3GPP TSG_CN#6
ETSI SMG3 Plenary Meeting #6,
Nice, France
13th – 15th December 1999

NP-99445

Agenda item: 5.1.3
Source: TSG_N WG1
Title: CRs on Work Item GSM-UMTS interworking

This document contains “20” CRs agreed by **TSG_N WG1** and forwarded to **TSG_N Plenary meeting #6** for approval.

Figure 6.2/TS 24.008: Session management states on the network side (overview)

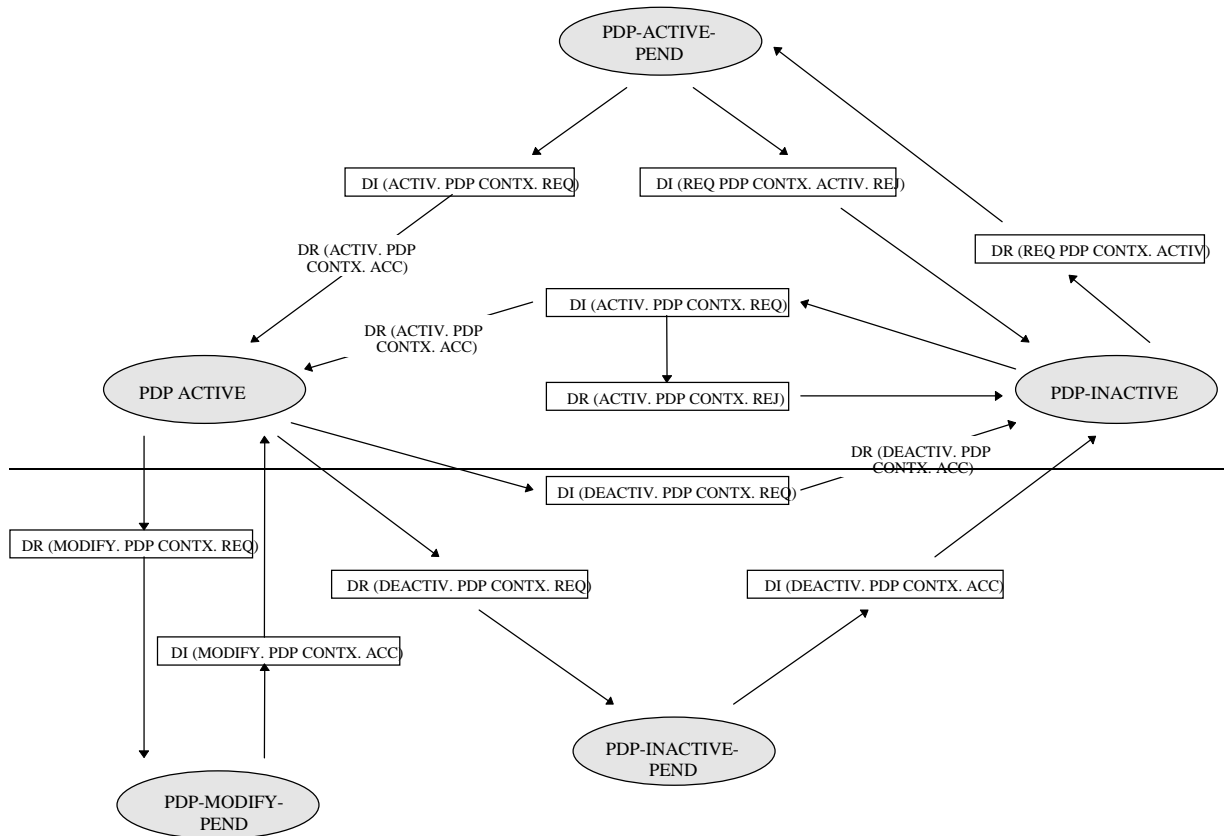
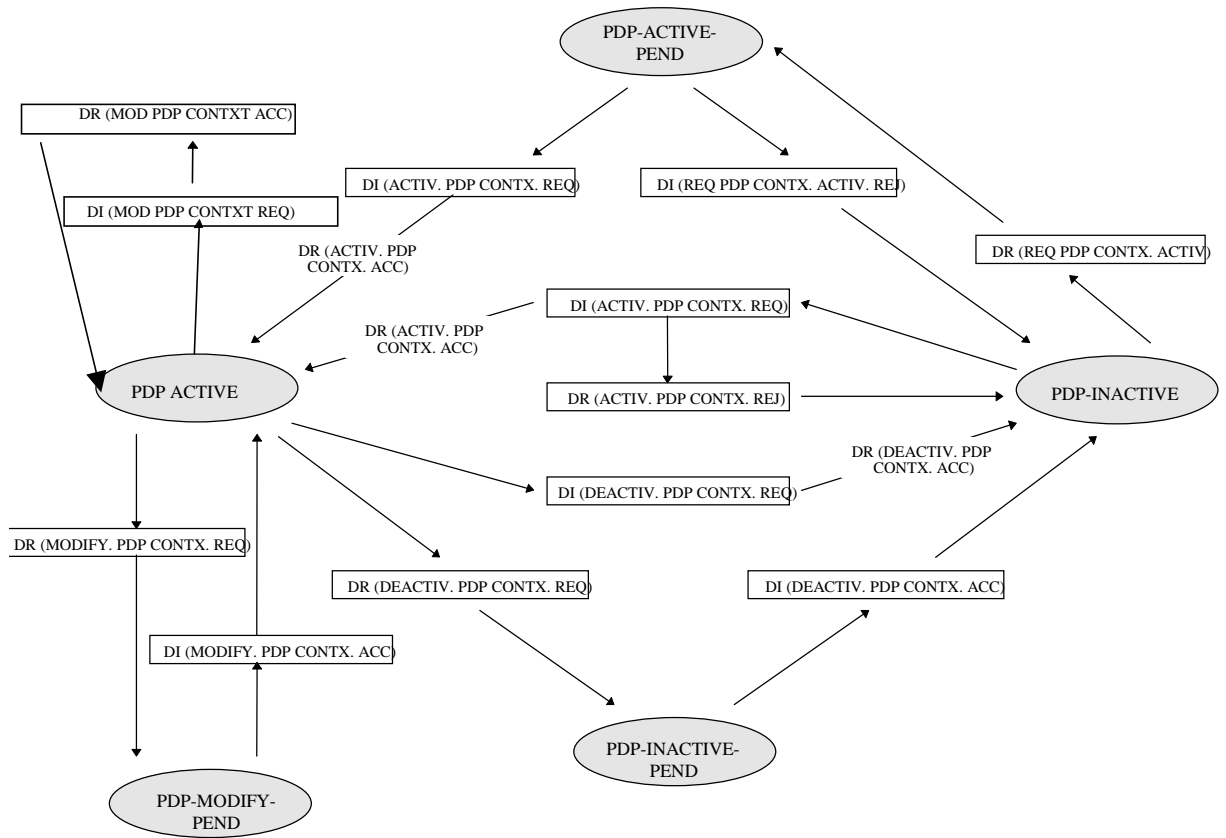
In this section, the possible states of an SM entity on the network side are described. As illustrated in figure 6.2/TS 24.008 there are five SM states on the network side.

It shall be noted, that Figure 6.2/TS 24.008 applies to both primary and secondary PDP contexts, though the distinction in messages regarding the activation of primary and secondary PDP contexts is not shown here for simplicity.

Figure 4.1b/TS 24.008:GMM main states in the MS

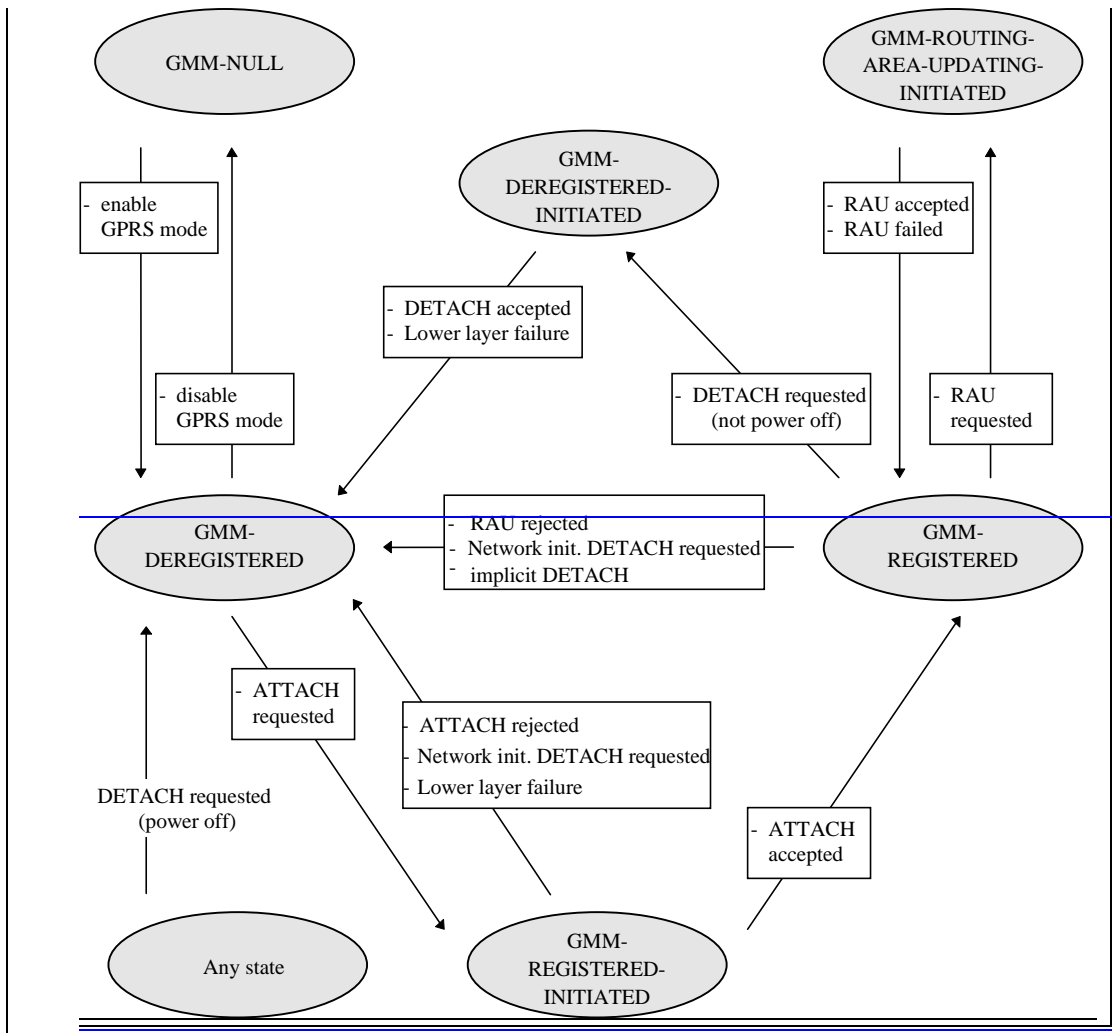
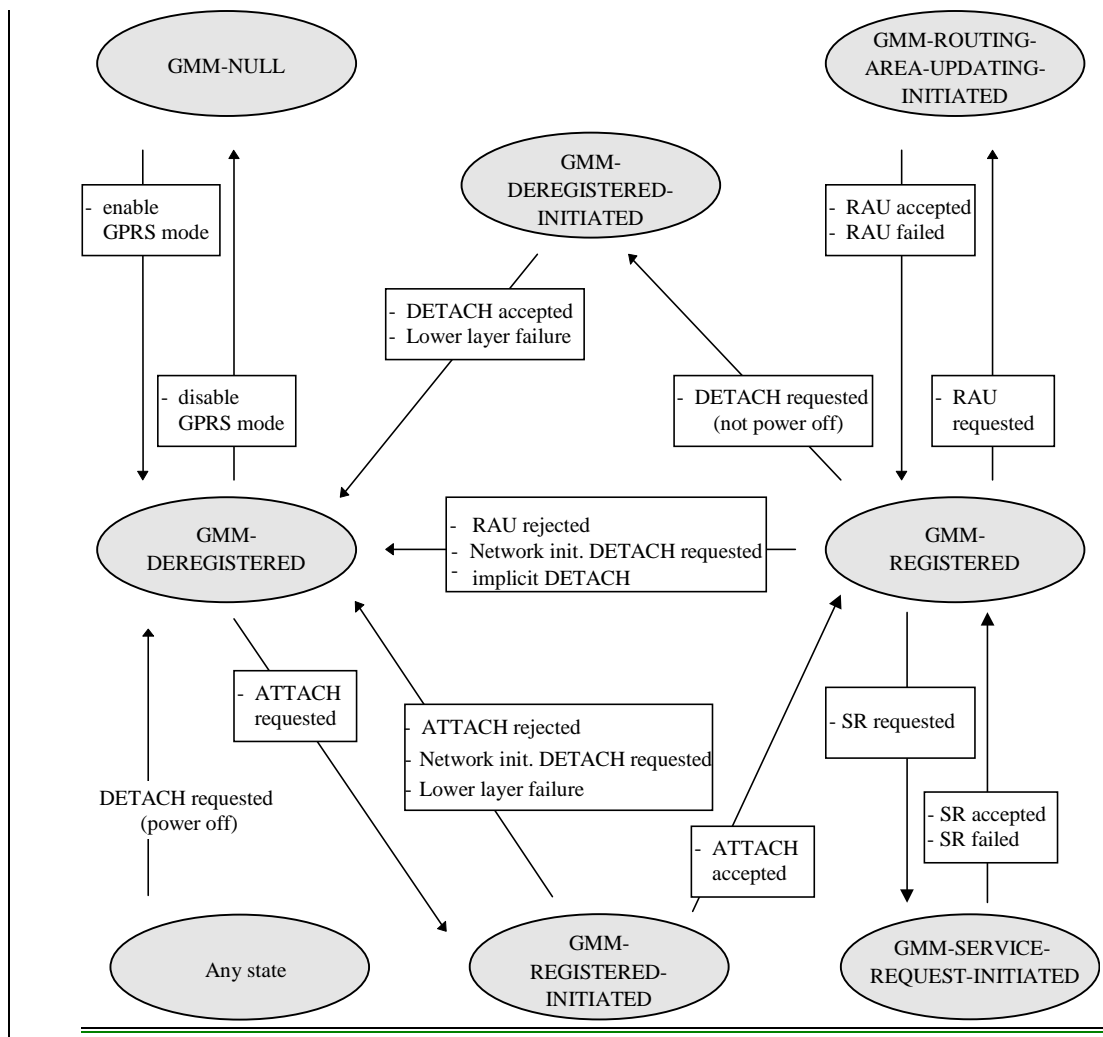
In this section, the possible GMM states are described of a GMM entity in the mobile station. Section 4.1.3.1.1 summarises the main states of a GMM entity, see figure 4.1b/TS 24.008. The substates that have been defined are described in section 4.1.3.1.2 and section 4.1.3.1.3.
